Hydro Hawkesbury Inc. (Hydro Hawkesbury)

2019 IRM Application

EB-2018-0040

Application Analysis

Ref: DVA Continuity Schedule, Account 1595

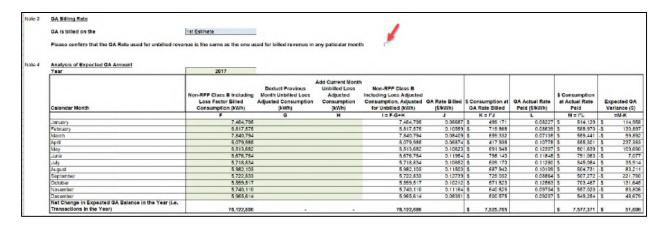
Please explain why the applicant is showing disposition amounts in the column titled "Disposition during 2018 instructed by the OEB" for accounts 1595 (2013), 1595 (2014), and 1595 (2015) when no balances were approved for disposition related to these accounts as part of the EB-2017-0048 Settlement Proposal (revised February 20, 2018).

HHI Response: see response to Question #3 above.
